Technical Note

Project: Rudloe Drive, Quedgeley

Subject: Drainage strategy

Client:	Linden Homes	Version:	0.0
Project No:	06396	Author:	
Date:	15/07/2022	Approved:

DRAWING TITLE
Area Contribution Plan

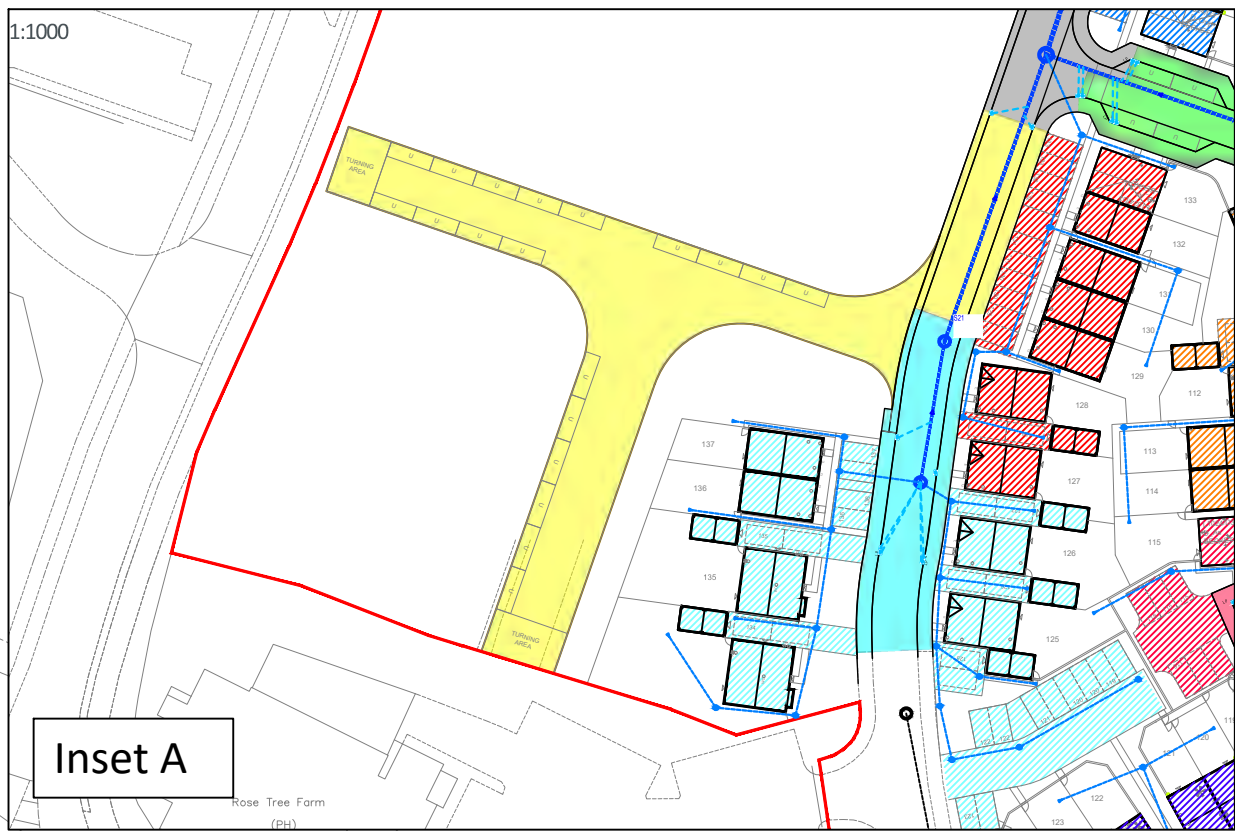
“This application refers to the reserved matters for planning consent 21/00490/OUT. That application showed the site developed in a way that required two attenuation basins with a total capacity for a volume of 432m³ such that surface water could be discharged to the adjacent watercourse at 24 l/s. The plan submitted for this application only provides

attenuation storage capacity of 347m³ to discharge surface water to the adjacent watercourse at 24 l/s. It is not clear where the layout offers any ability to reduce the attenuation storage capacity by 22%.”.

Sewers in Newhaven Road flow from south to north, out-falling in balancing pond 5 of the overall site wide drainage strategy. Sewers in Newhaven Road take flows from upstream sewers located within Rudloe Drive.

The total impermeable discharged to the existing network by this location is 1.607 ha compared with an allowable 1.820 ha.

Appendix F PJA Flood routing plan

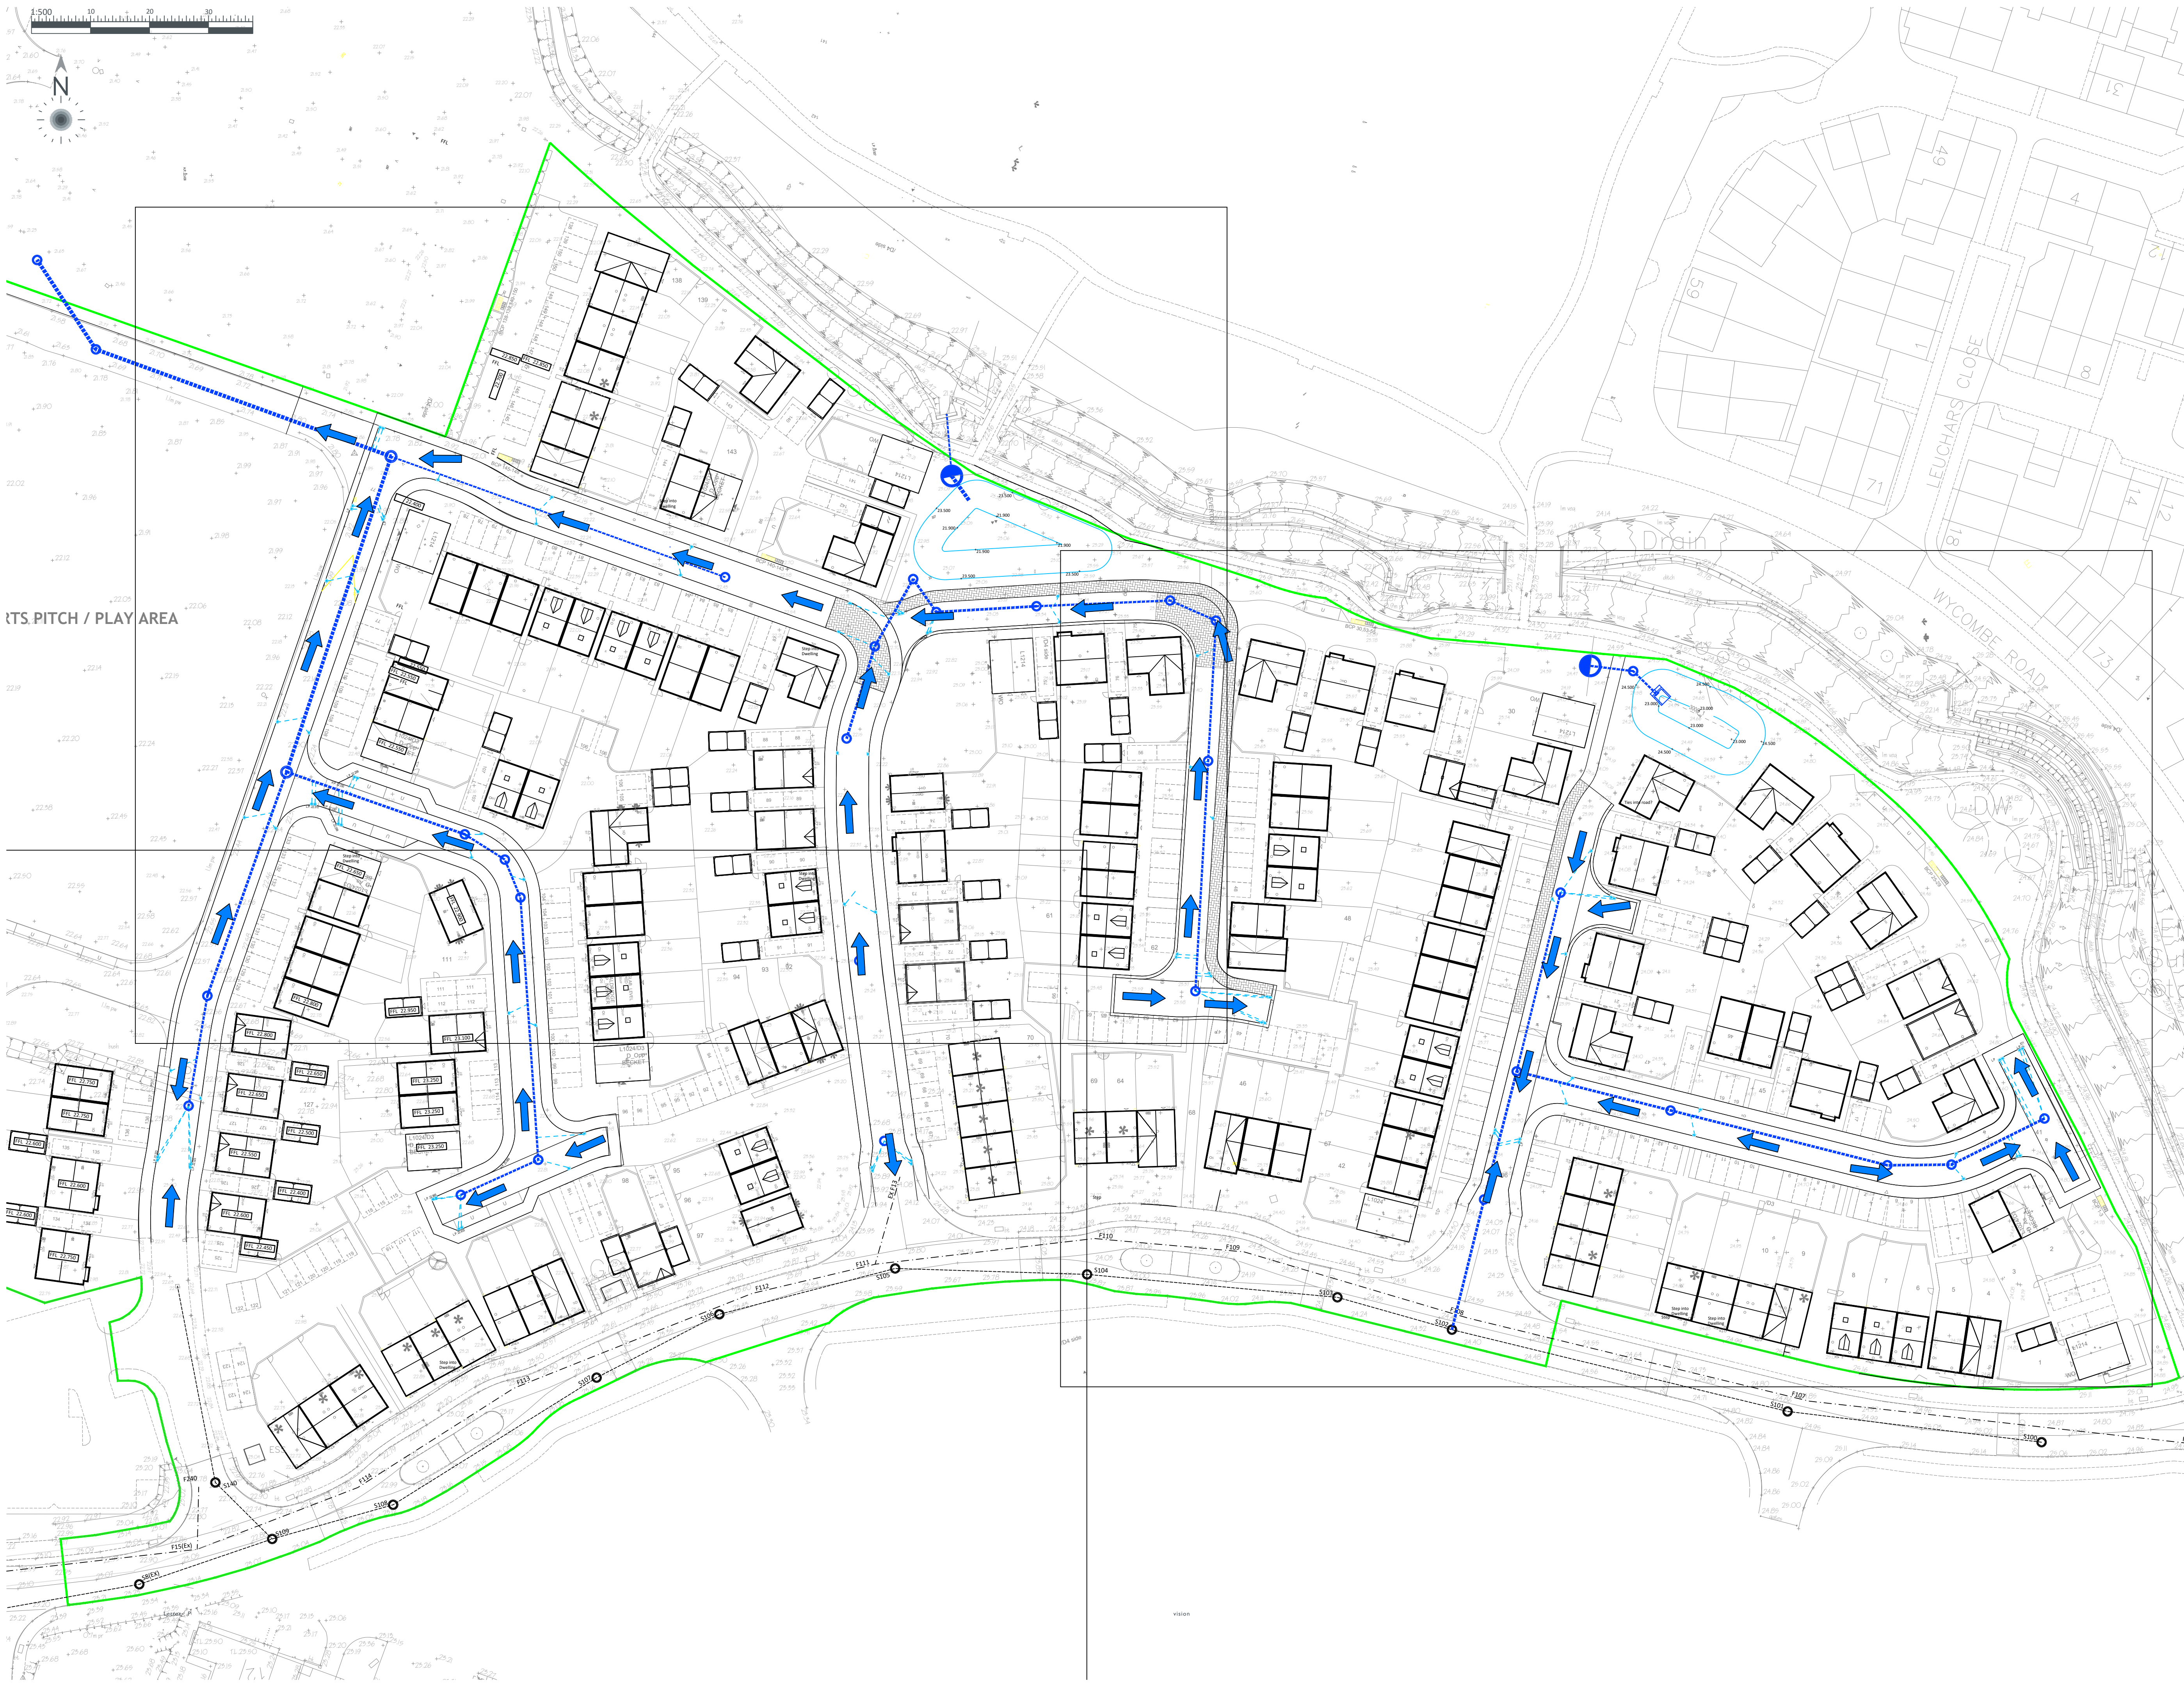
“Further, the drawing showing surface water flow direction arrows shows (Sht 7 of land-north-of-rudloe-drive-2200533rem-plans-2-of-2.pdf) a point of convergence at the junction of the roads in the eastern half of the development. This would suggest there will be ponding of water at this junction in front of units 38 and 39. It would be useful to have an indication of how deep this pond may get and how far it might spread”.

Therefore, exceedance flow routes are shown to demonstrate the flow paths that would be followed during an event that exceeds that modelled or blockage/failure of the system. If one

of these scenarios were to occur, the flooded volume of water would be retained within the kerbs of the road carriageway, until such a time where the water dissipates in the system. Once the water within the network starts flowing again, the flooded water can flow back into the system through the proposed gullies at the designed low point of the road.

The proposed exceedance flood routes are shown on PJA drawing 0402-P1. And this is included within Appendix F.
